Our Ref: D18/130509

**Re: Amended Scheme 396 Lane Cove Road & 2 Coolinga Street, Macquarie Park**

**Response to Council on MOD 2 to MP 09\_0209  
396 Lane Cove Road & 2 Coolinga Street, Macquarie Park**

**Figure 1 Modification Application Plan Ground Floor**

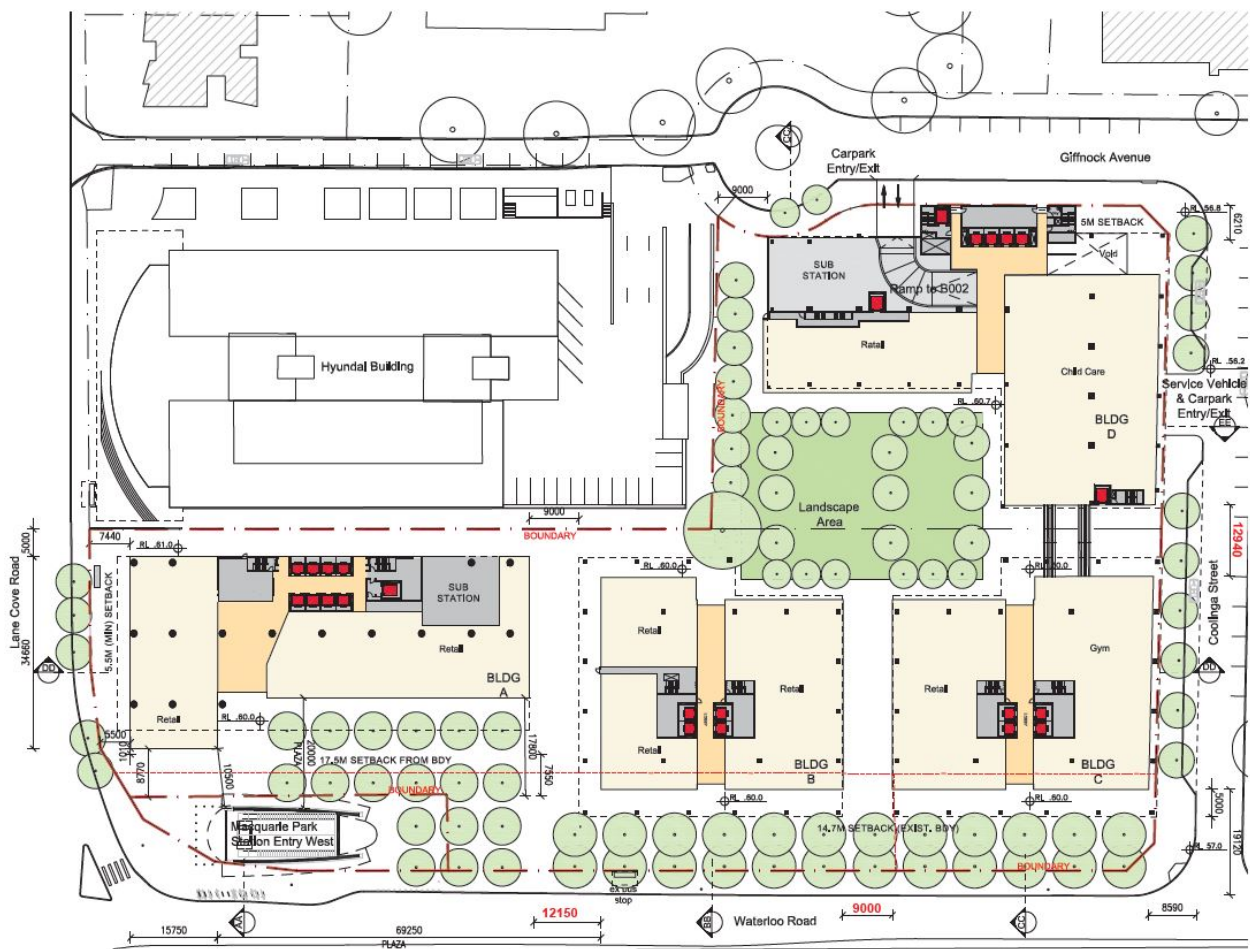
The UDRP commented that the intent of the active laneway concept is supported, which is achieved by narrowing the separation distances between buildings to accommodate the relocation of the mass and to achieve a more intimate laneway character. Concerns were raised with regard to visual connections to the centre of the site and the building separation to the Hyundai building.

- The revised building envelopes do not diminish the physical connectivity of the site or view lines to the centre of the site. Whilst the width the through-block connections have been reduced to accommodate

the public plaza and park areas, as well as create an intimate laneway scale, view lines to the centre of the site are in the same general locations as approved (see **Figures 1 and 2** above).

Buildings	Ground Level	Upper Level
A – B	13.15m	10.00m
B – C	10.00m	10.00m
C – D	19.60m	12.50m

The Amened Scheme proposes to increase the separation between buildings from the original Modification Scheme, to a minimum of 10m and with generally greater ground floor separation distances. Creating the activated laneways is key to providing greater public benefits on the site in terms of the increased public plaza, increased and more functional open space areas, and improved site activation for a more inviting ground plane.
